Burlington Development Review Board

Tuesday, June 20, 2023, 5:00 PM

AGENDA

MEMORANDUM

PROPOSED SITE PLAN

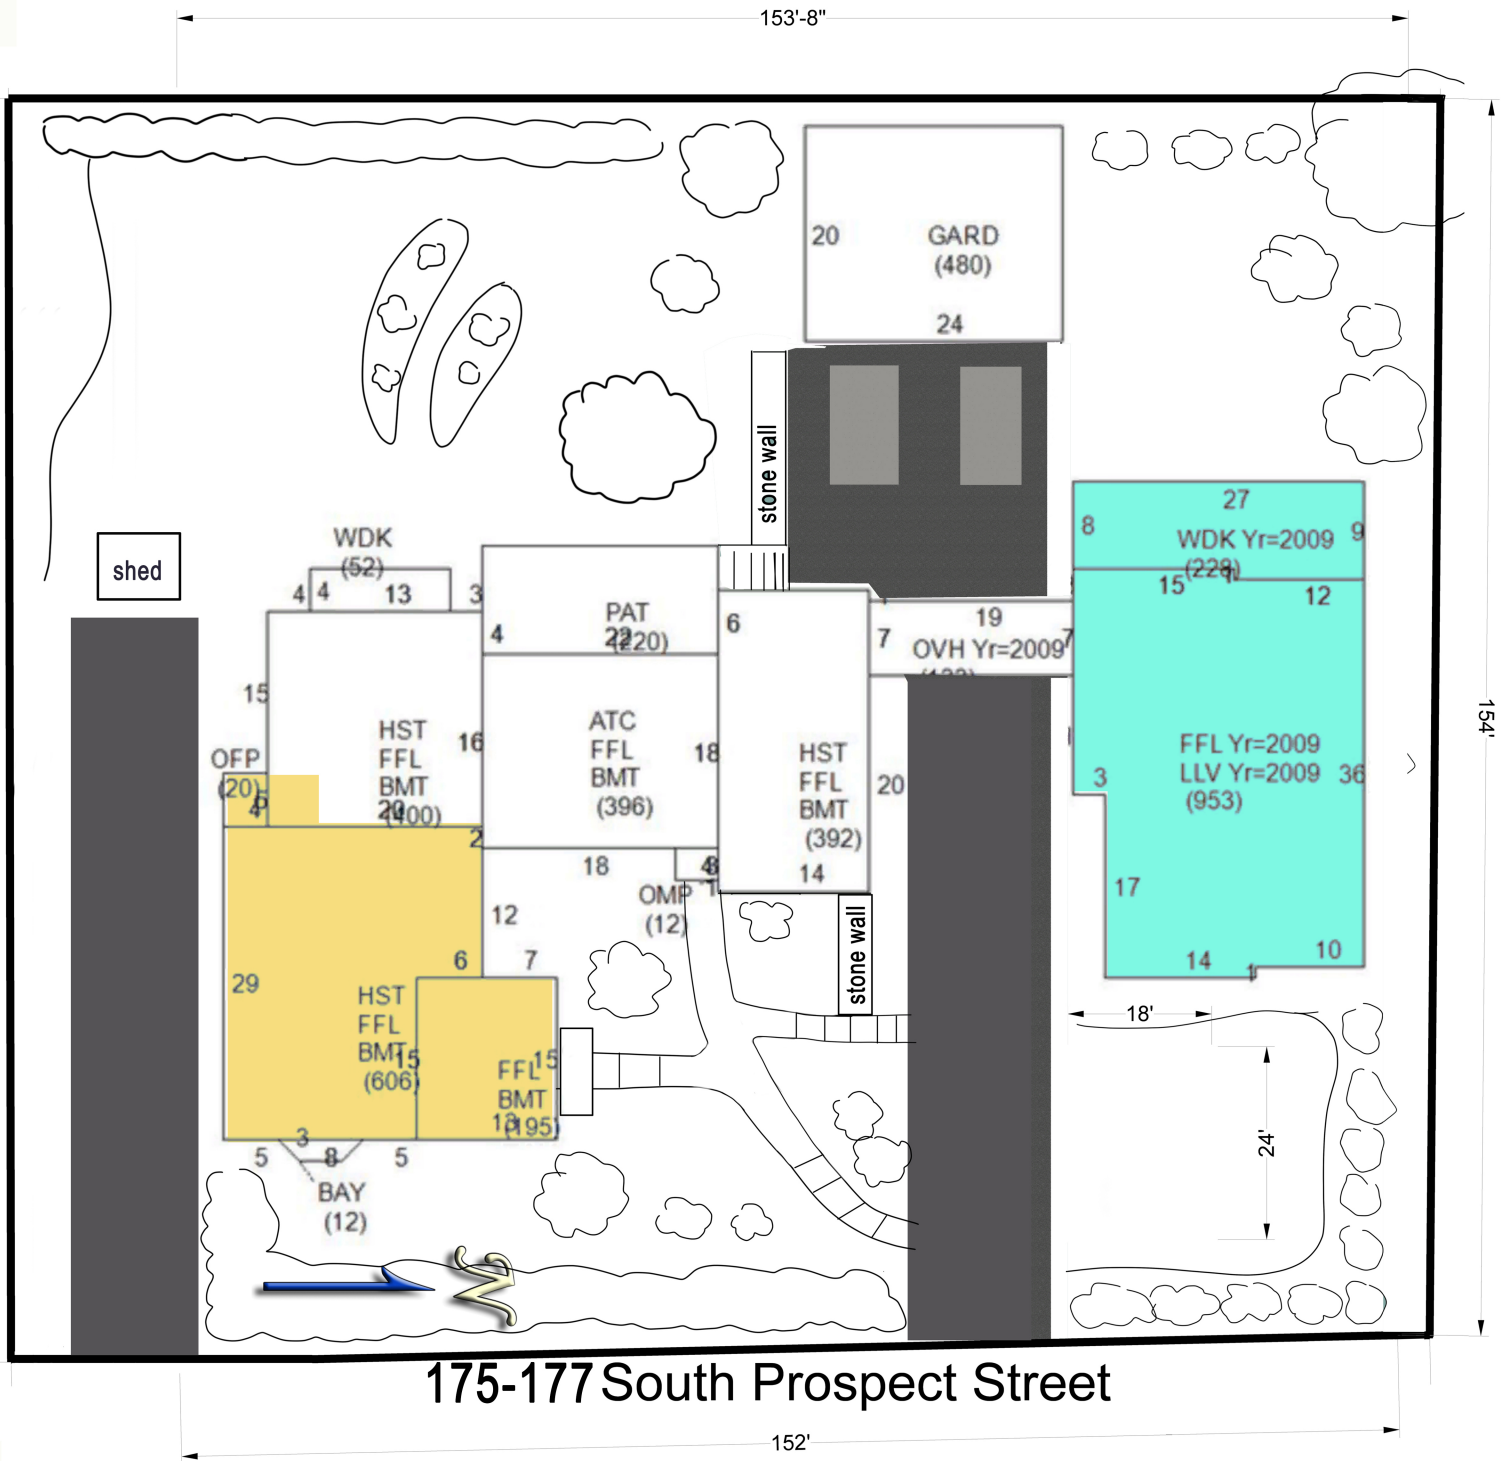
Eleanor Lanahan: The challenge created by parking cars in tandem is one or more cars are always blocked by the bottleneck driveway. The zoning comment says no hardship has been created, but I disagree. It is inaccurate to say this because of the slope of the existing terrain. The hedges on the front of the residence would create a buffer that would block any indication that parking is in the front yard setback. Most of my neighbors have parking in their front yards as evidenced by the pictures. If the variance is denied based on inconsistencies with the character of the neighborhood, this would be unjust as evidenced by neighbors who exceed parking in the front and side setbacks. Parking lots along South Prospect Street are also evident within the front yard setback. This distinction is in violation of the existing ordinance. My intent is to make responsible use of my private property to find a solution for this unique parking situation.

DRAWING NO.
B1

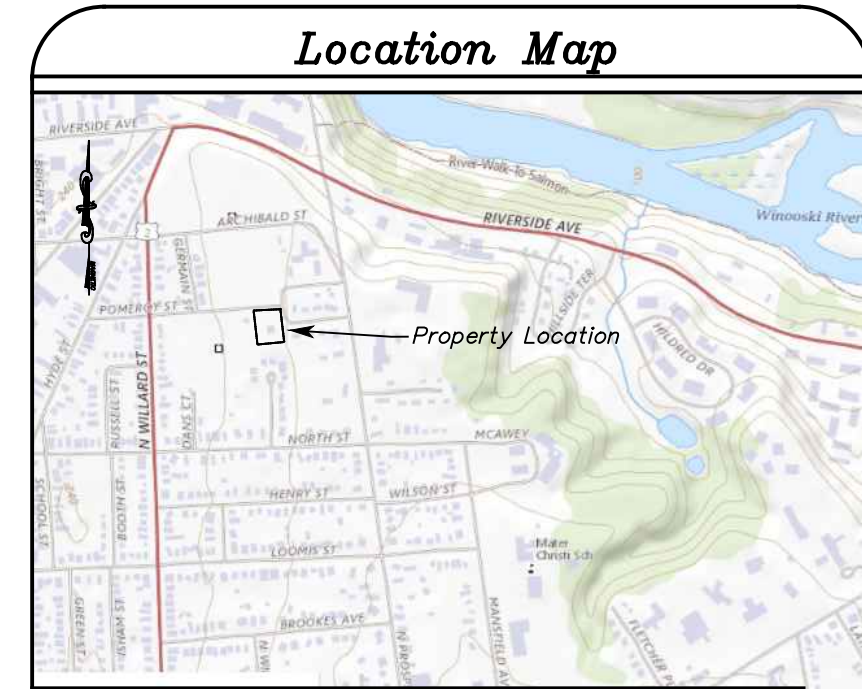
This criterion requires that the final plat plan be drawn at a scale of 1" = 40' and be on sheets sized 24" x 36" with one inch margins on three sides and a two inch margin on the side to be bound. The final plat plan will need to meet these scale and margin size requirements.

2. **Prior to filing the mylar** in the city land records, the subdivision plat shall be revised to reflect the following:
 - a. Sheet size of 24" x 36" with one-inch margins on three sides and a two-inch margin on the side to be bound;
